ADDENDUM 2

DATE: February 22, 2017
PROJECT: JLL Roof Replacement and Waterproofing Project
RFP NO: 744-R1712
OWNER: The University of Texas Health Science Center at Houston
TO: Prospective Proposers

**UNIVERSITY OF TEXAS HEALTH SCIENCE CENTER
JESSE JONES LIBRARY
ROOF REPLACEMENT AND EXTEIOR WALL REPAIRS/RESTORATION
1133 JOHN FREEMAN BOULEVARD
HOUSTON, TEXAS**

**ADDENDUM NO. 1
FEBRUARY 17, 2017**

PENTHOUSE GENERAL NOTES:

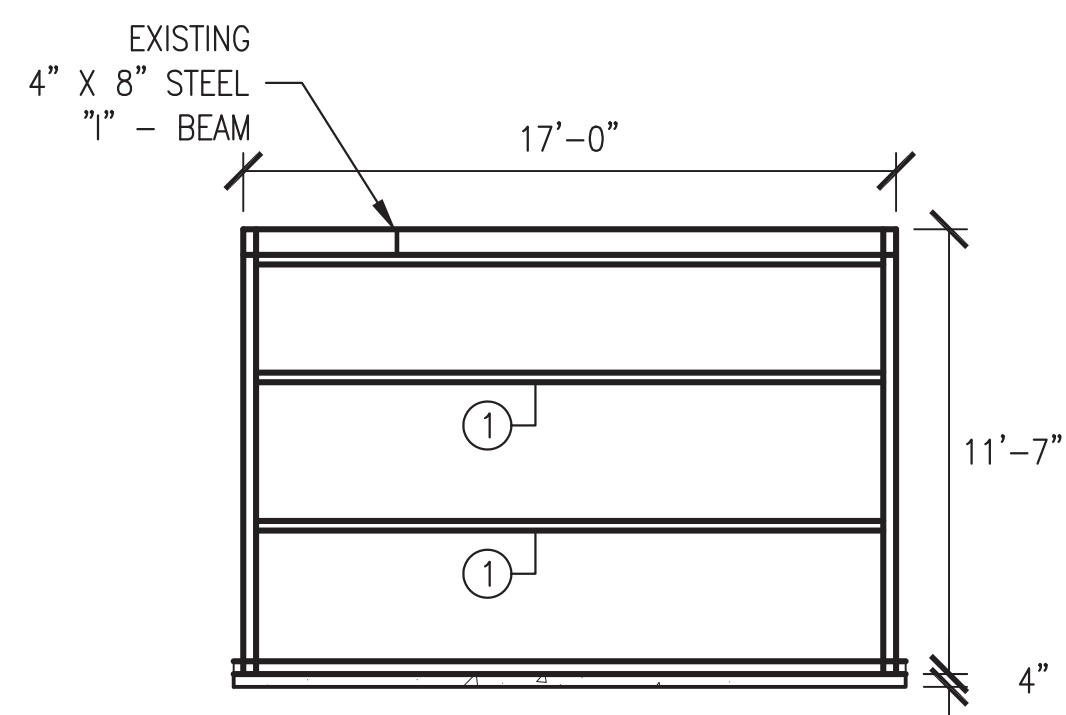
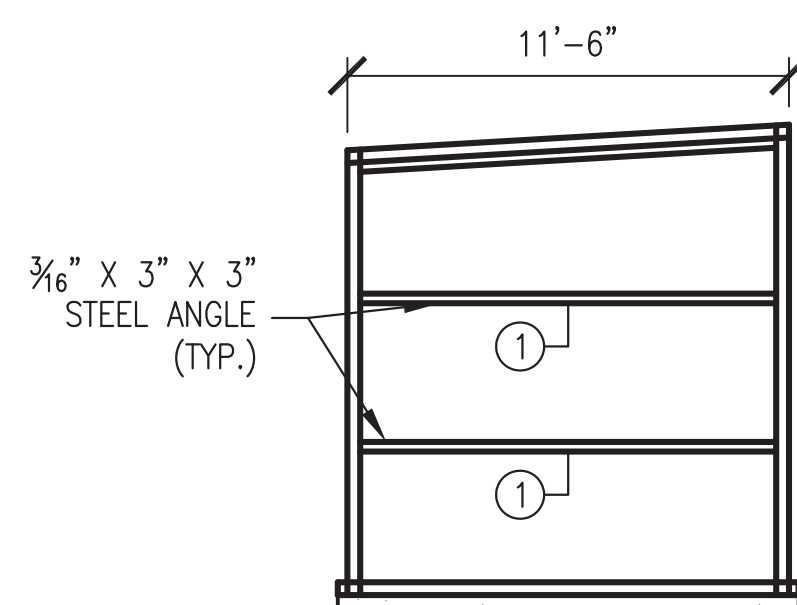
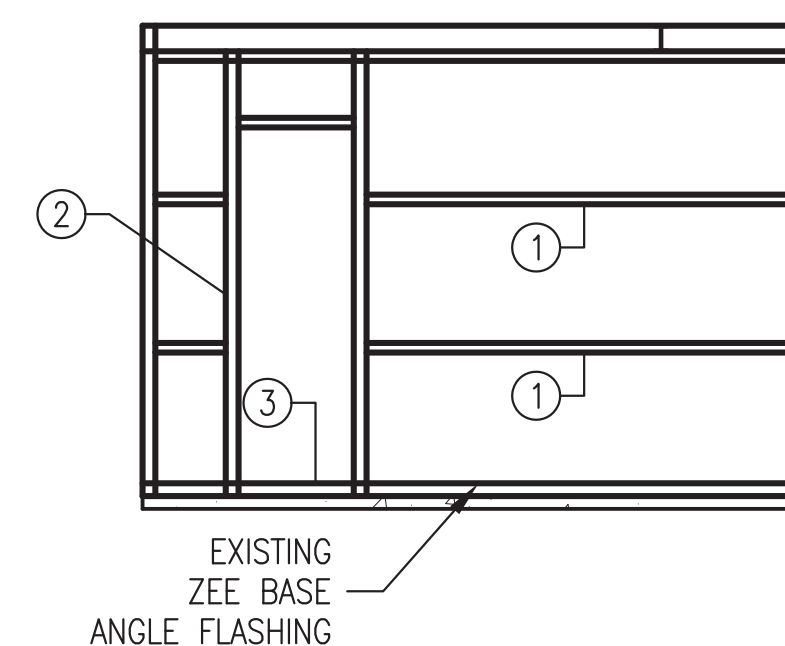
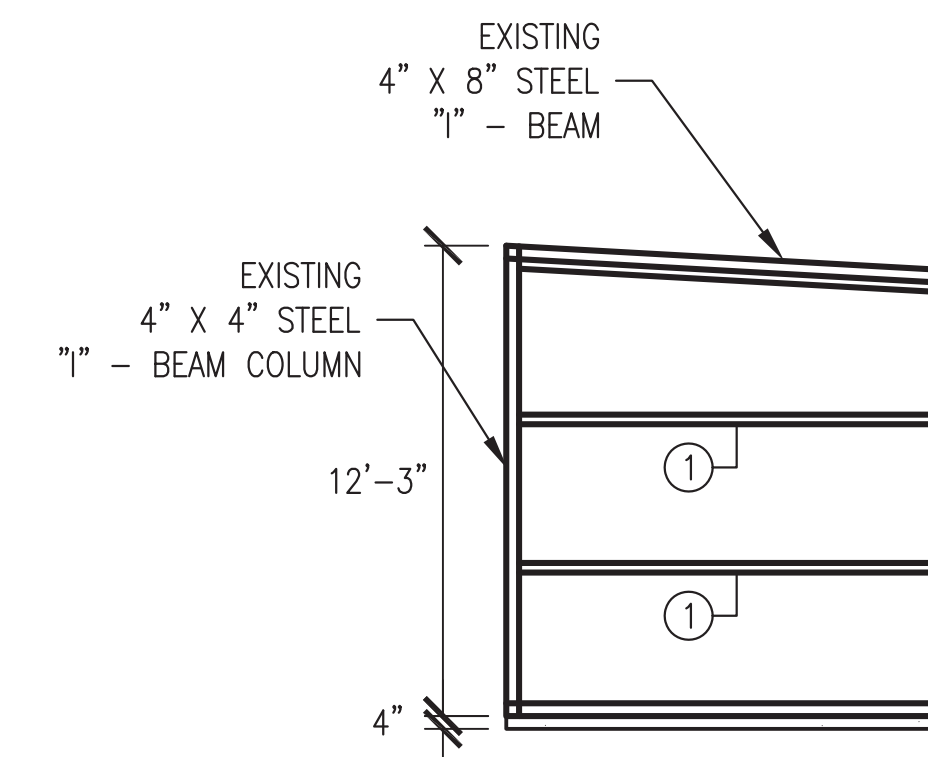
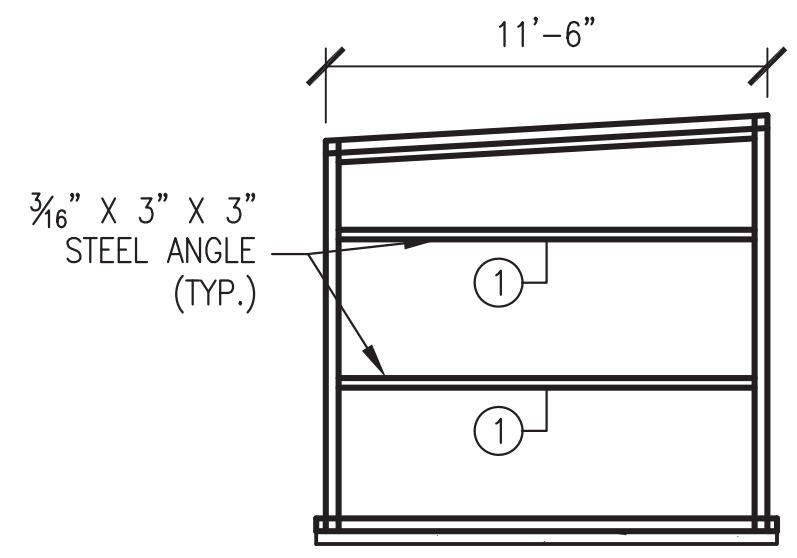
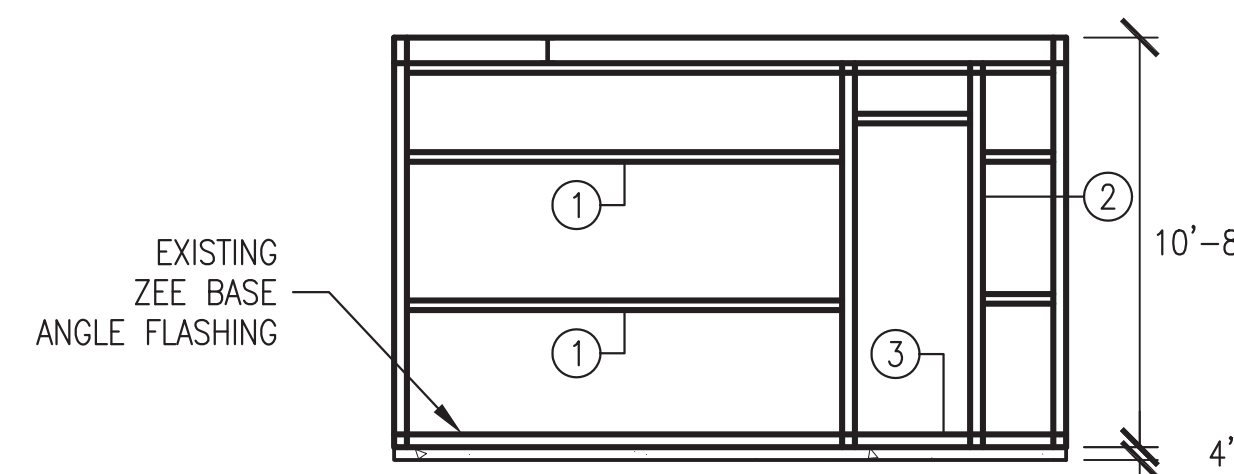
10. Sheet R3.05 – Structural Elevations: Penthouse General Notes: Change Repair Note “1” to read as follows; “Add 10 gauge Zee furring support to penthouse structures”; Add Repair Note “4” – “Move existing electrical boxes, conduit, and other equipment as necessary”. Reference attached revised Sheet R3.05.

- ① ADD 10 GAUGE ZEE FURRING SUPPORT TO PENTHOUSE STRUCTURES.
- ② MODIFY EXISTING HEIGHT AT DOOR LOCATIONS.
- ③ INSTALL CONCRETE CURB BENEATH DOORS.
- ④ MOVE ELECTRICAL BOXES AND CONDUIT IN AS NECESSARY.

29 METAL RAKE EDGE AT PENTHOUSE
 R5.03 SCALE: NOT TO SCALE

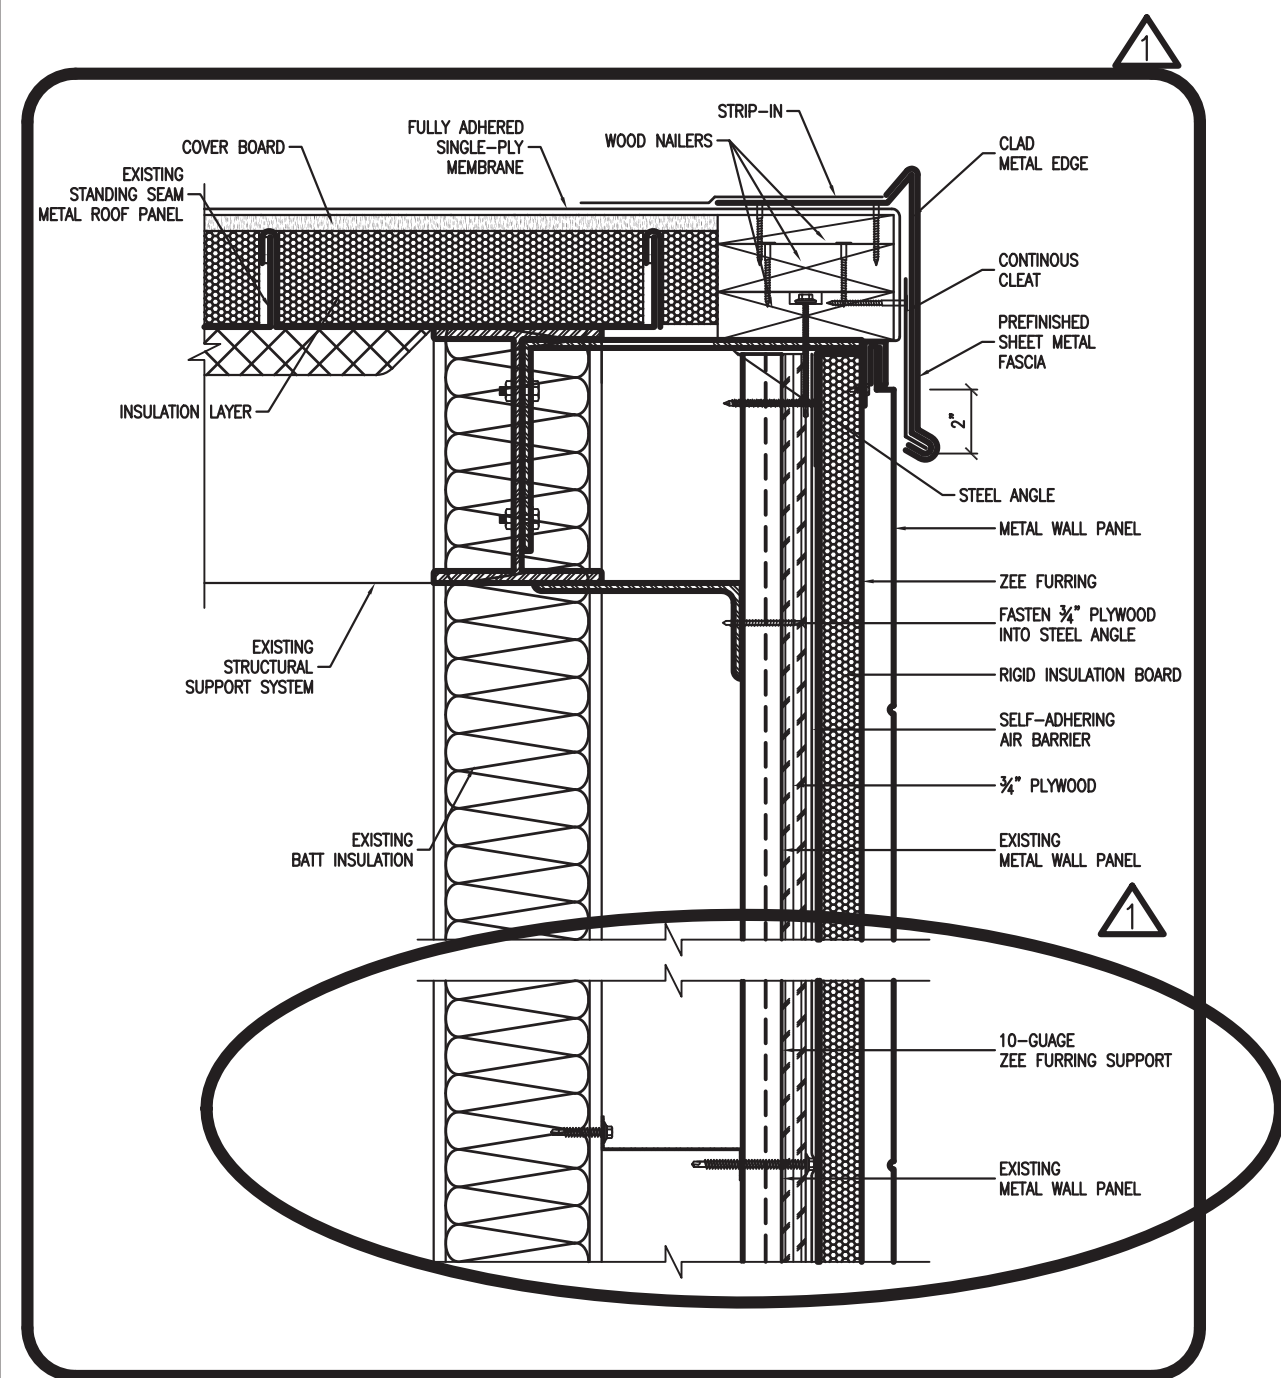
11. Sheet R5.03: Details 29/R5.03 and 31/R5.03: Revise details to illustrate space between existing structural steel and inside surface of existing metal panels; Revise details to illustrate intermediate horizontal Zee furring. Reference attached revised Sheet R5.03.

31 METAL EDGE W/GUTTER AT PENTHOUSE
 R5.03 SCALE: NOT TO SCALE

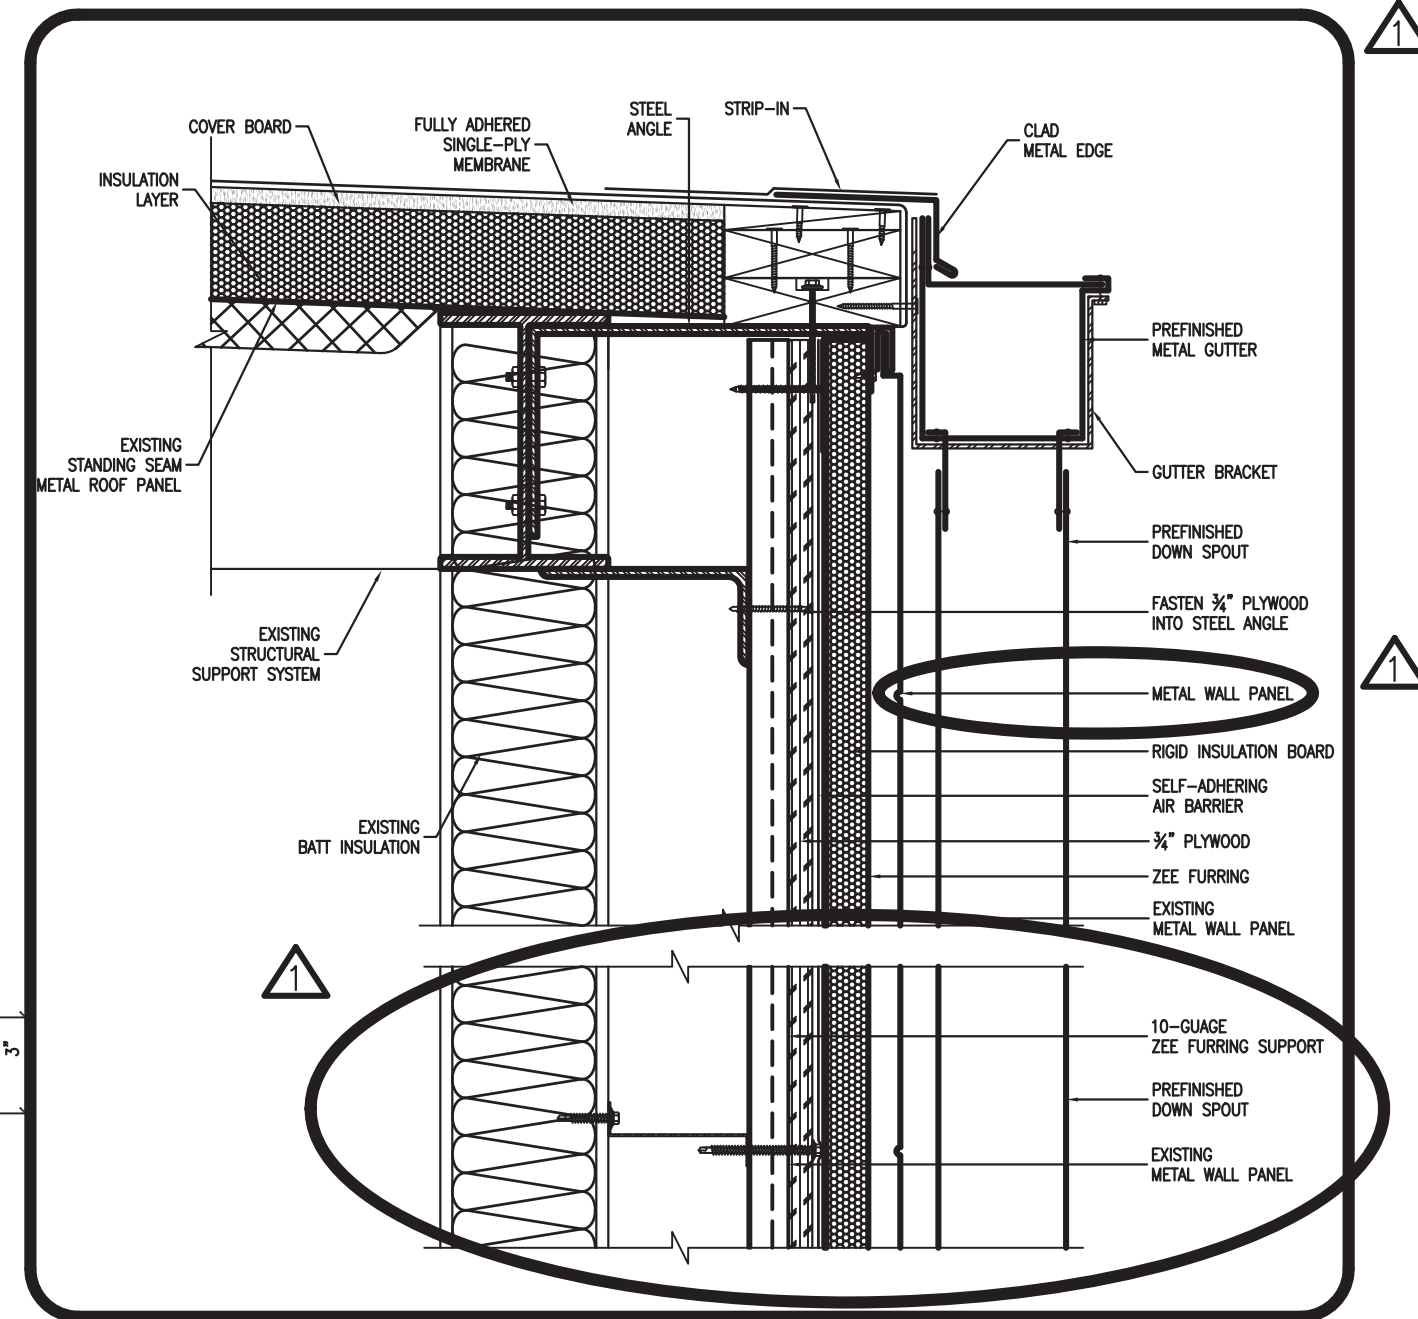
12. Sheet R5.03: Details 31/R5.03: Revise detail note to eliminate word “existing” at exterior metal wall panel. Reference attached revised Sheet R5.03.
